**THI QAR BEE FARM
THI QAR, IRAQ**

**SIGIR PA-09-188
APRIL 1, 2010**

Summary of Report: PA-09-188

SUBJECT: Report on the Thi Qar Bee Farm, Thi Qar, Iraq (SIGIR Report Number
PA-09-188)

Figure 1. Conceptual design of honey processing facility (Courtesy of GRS)

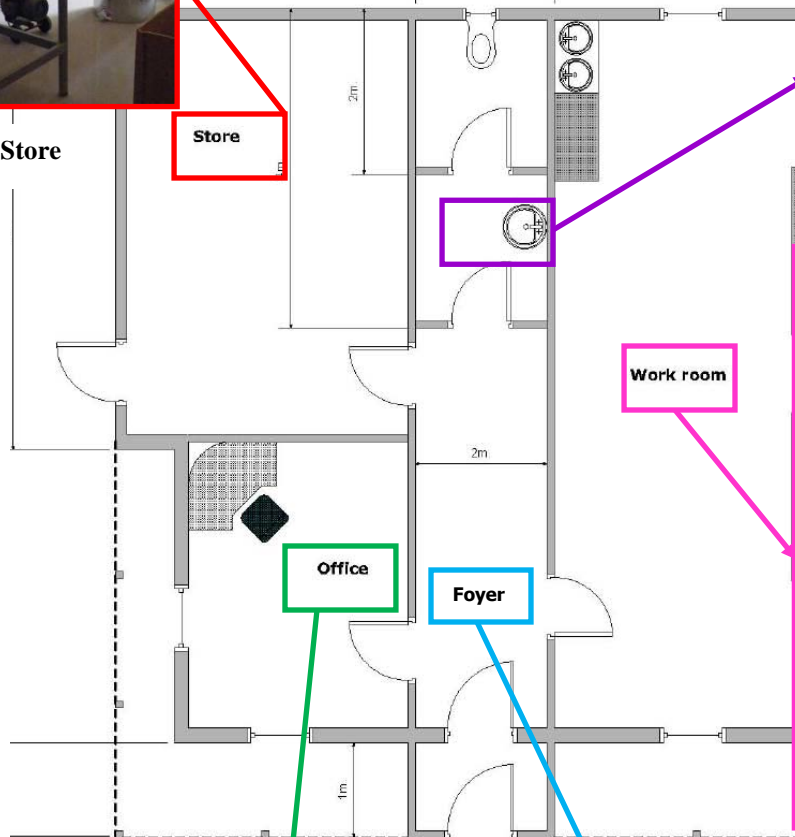
The building was constructed with three primary rooms and one restroom (Figure 1). The finish in all of the rooms was similar—plaster and painted finish for the walls, and ceramic tiles for the flooring. The finishes appeared well applied and in good condition.

When entering the building through the foyer, the office and store are located on the left, the restroom is straight ahead, and the work room is on the right. The store area was equipped for processing honey and was well-maintained (Site Photo 7). Several tables were available for workers to perform the various tasks required for processing, and equipment was located in this area.
